Memorandum

Subj: Mediterranean Village – Coral Gables, Florida
Responses to Outstanding Transportation/Parking Items

The purpose of this memorandum is to provide updates/responses addressing outstanding transportation/parking related items identified by City Planning and Zoning staff the week of May 18, 2015. Note that this memorandum serves as a follow up the supplemental information provided to City staff on the traffic impact study, valet operations study, and shared parking study dated May 18, 2015. The following summarizes updates/responses to these outstanding items:

ATTACHMENT C:
HOTEL SPECIAL EVENT VALET
OPERATIONAL PLAN OPTIONS

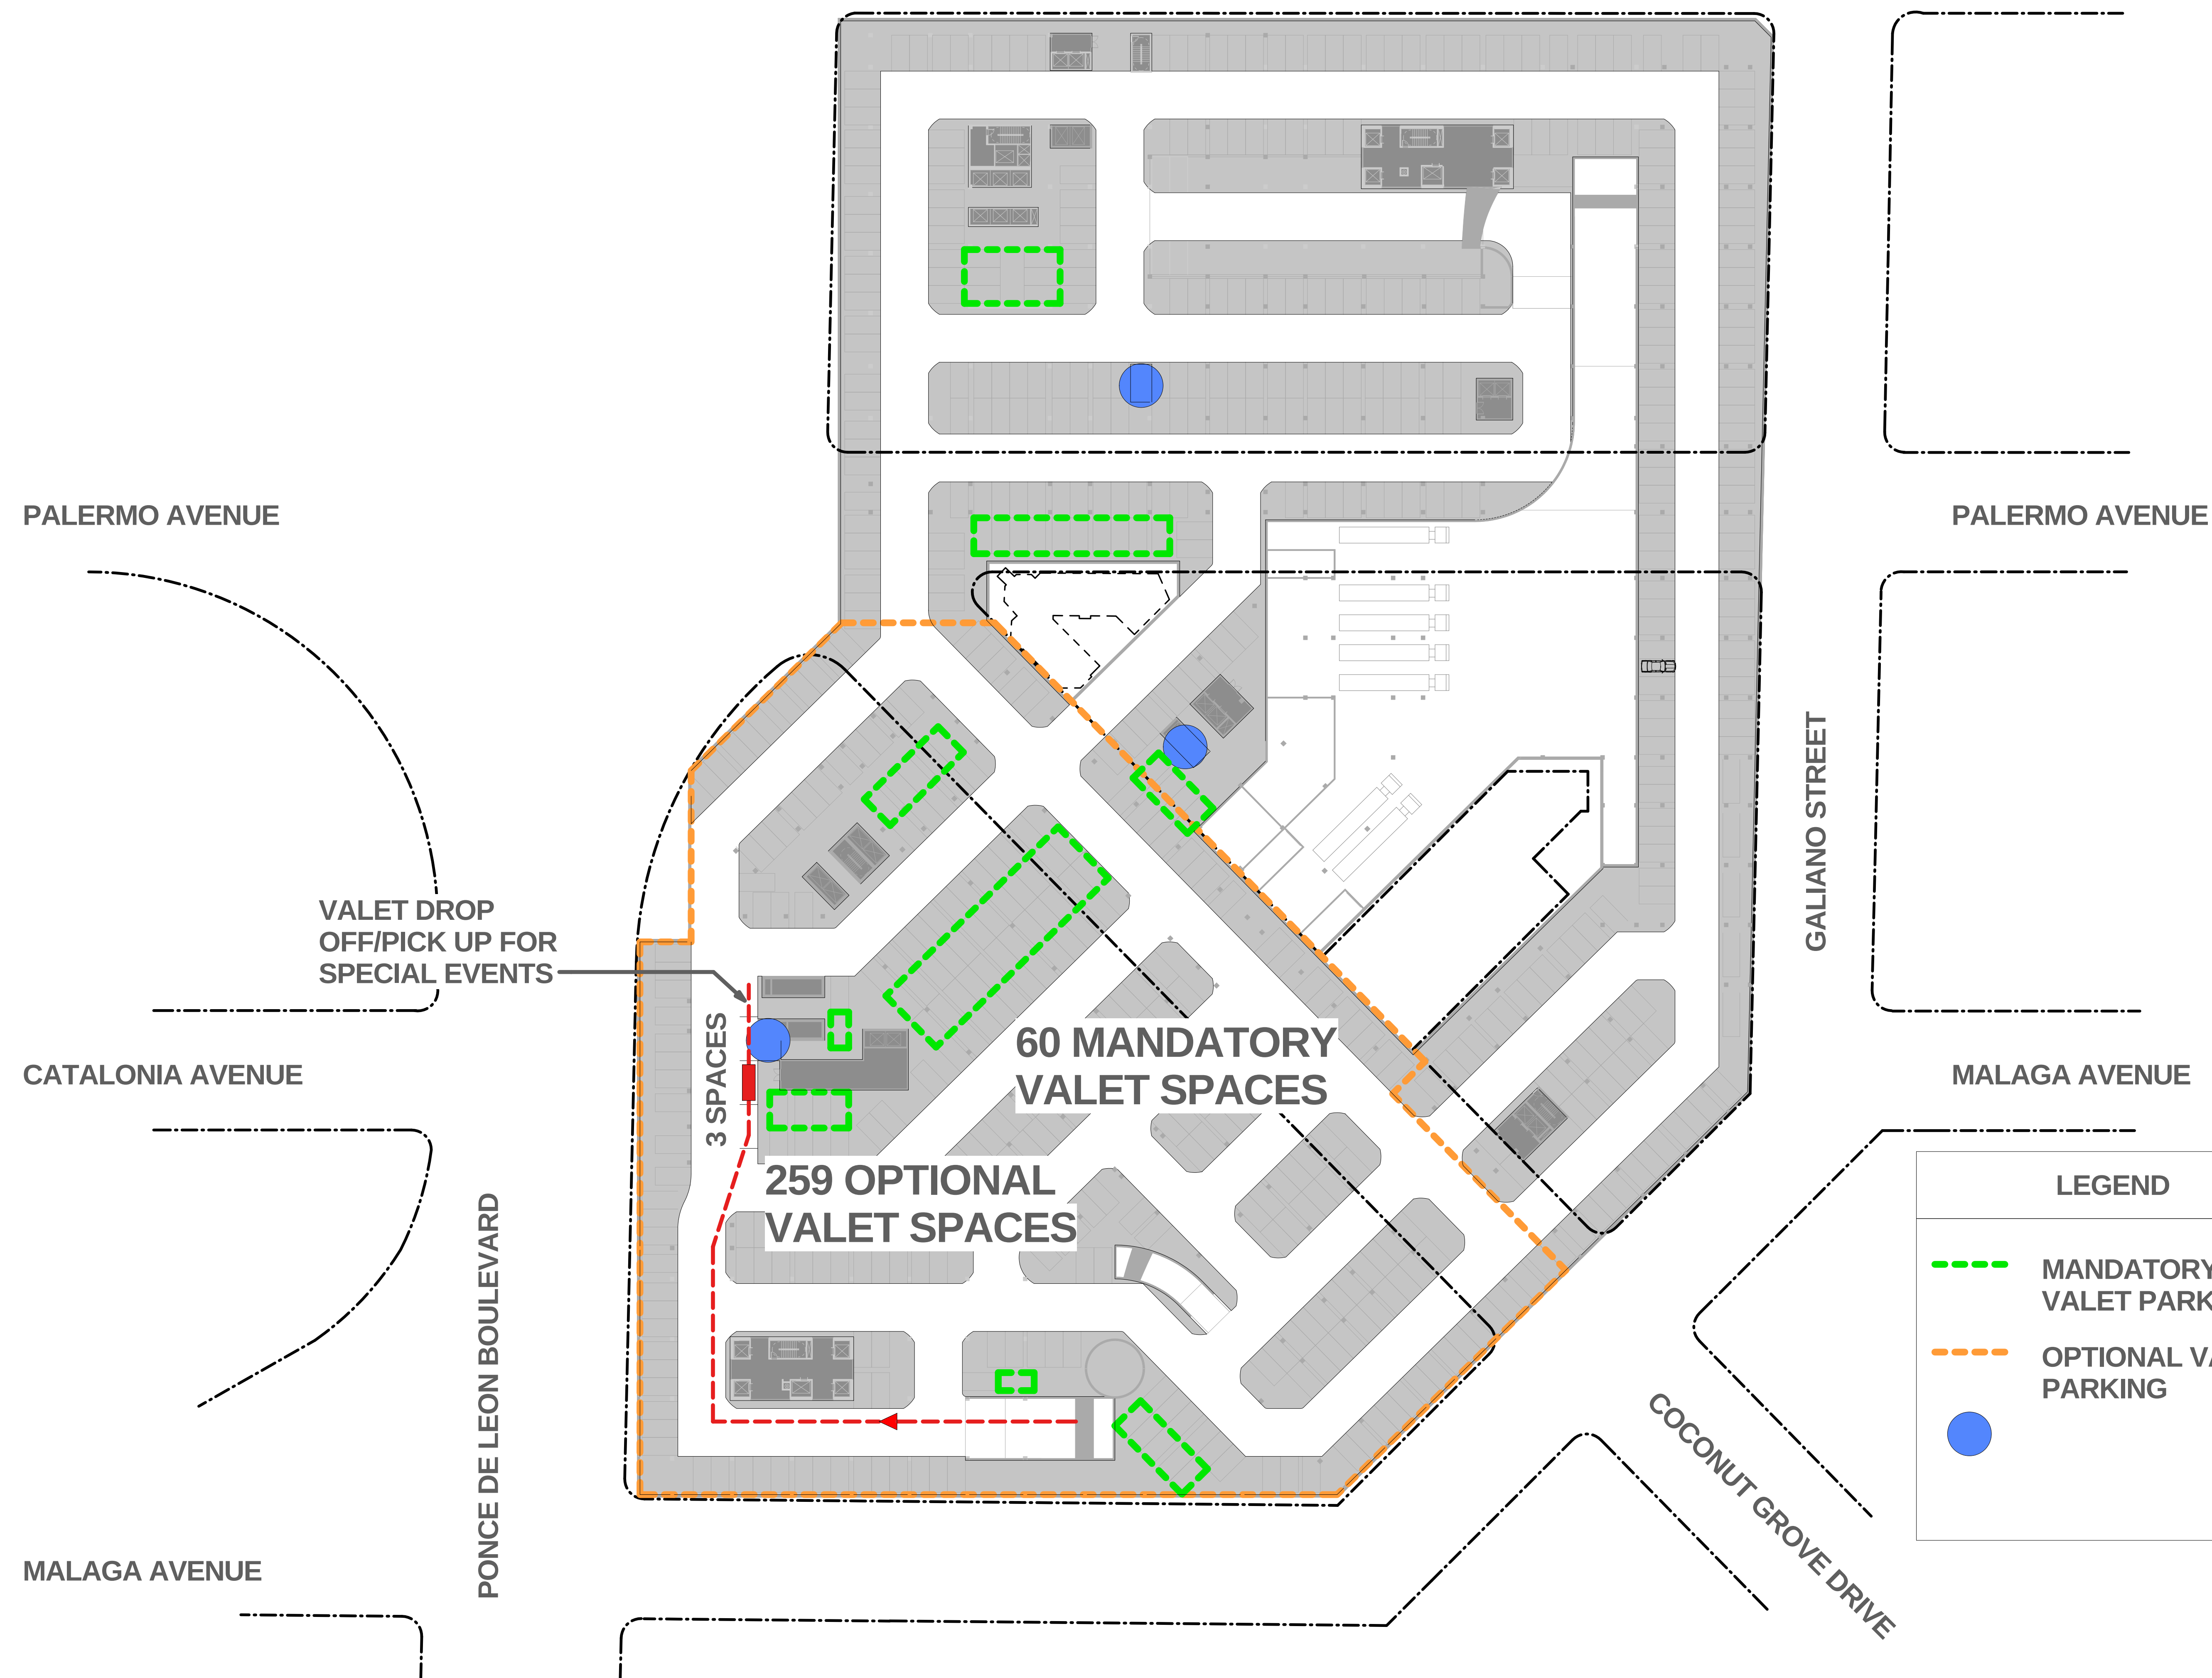
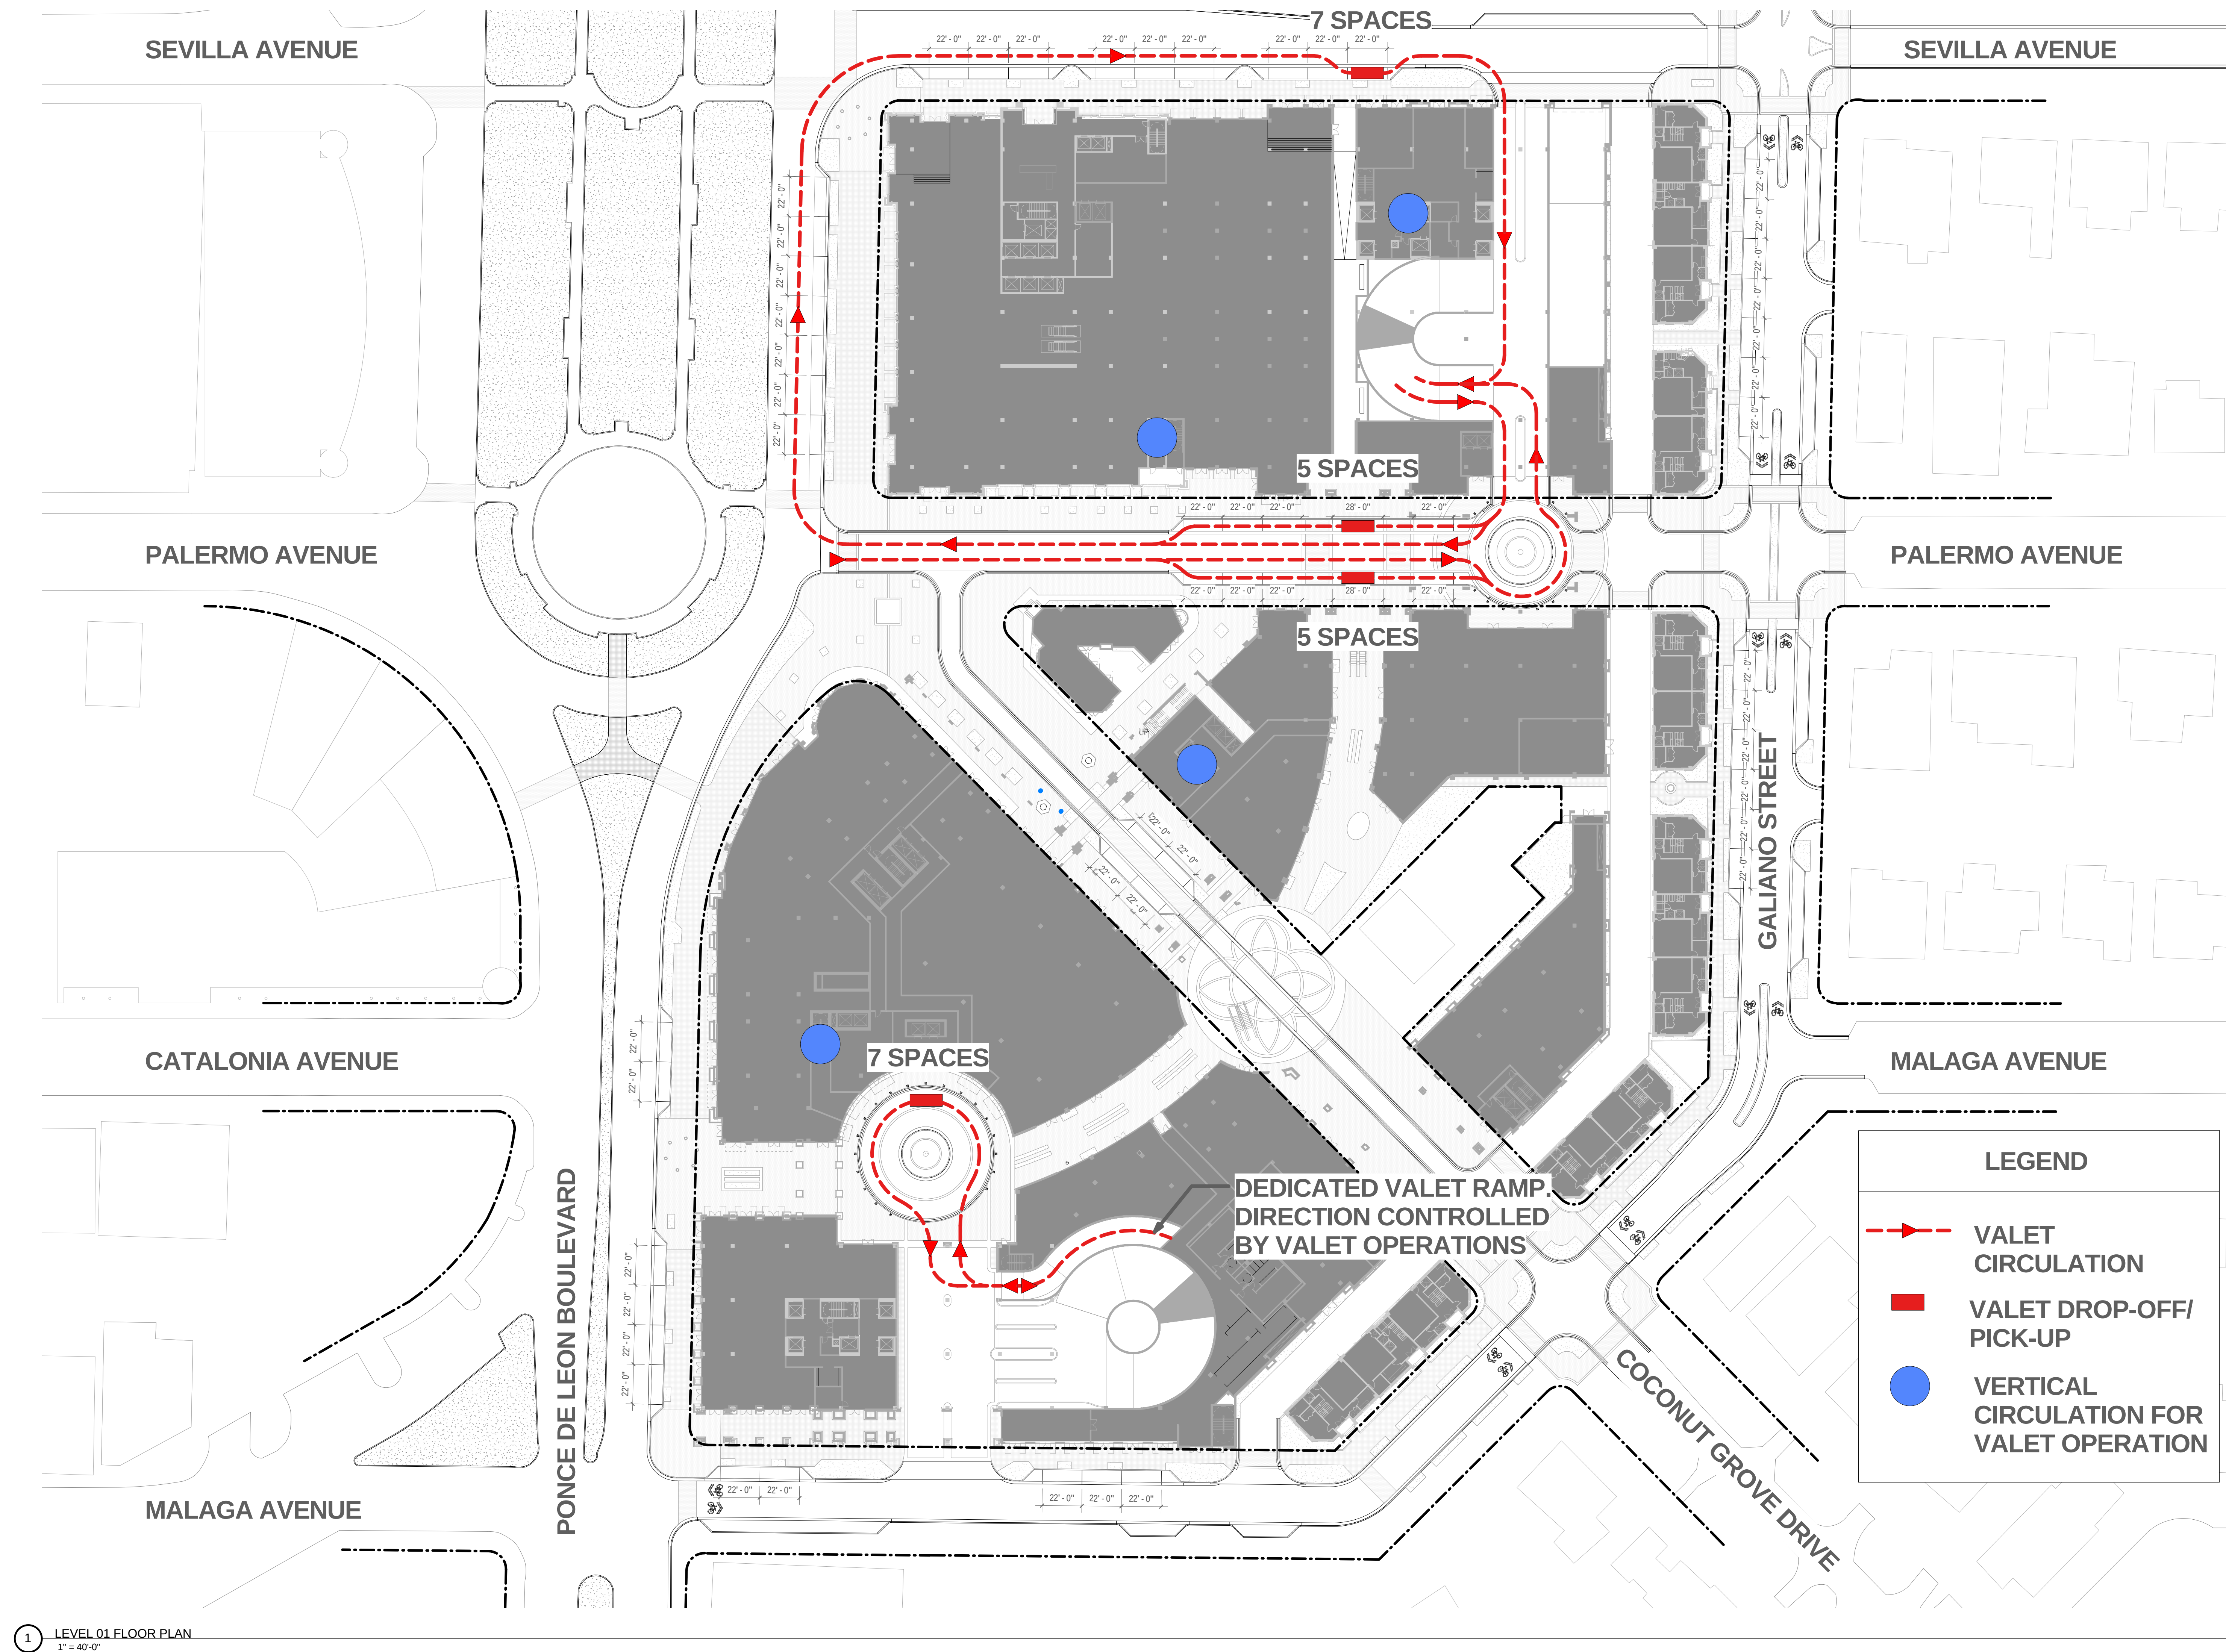
4. Hotel Special Event Valet/Self-Park Operations Plan

It is our understanding that staff has concerns regarding the parking operations (valet and self-park) during a special event at the hotel's ballroom facility. The current hotel valet operations plan proposed that all valet drop-off/pick-up activity occur at the main hotel roundabout via Malaga Avenue. Valet vehicles would then enter/exit the lower floors of the parking garage via the parking helix located along the same access driveway mixing with self-parking vehicles visiting the project.

In order to facilitate the peak volumes associated with an event at the hotel, operational and site plan modifications can be implemented to separate valet vehicles from self-parking patrons as they enter the parking helix. The revised site plan includes the construction of a direct access ramp from the hotel along the northern edge of the current helix design to/from the lower parking levels. This one-way, reversible, valet-only ramp would supplement the existing hotel helix. During peak arrival times, the ramp would operate as a one-way downward ramp while operating as an upward ramp during peak departure times. In addition, a lower level valet stand can also be provided during hotel events. Refer to Attachment C for additional details.
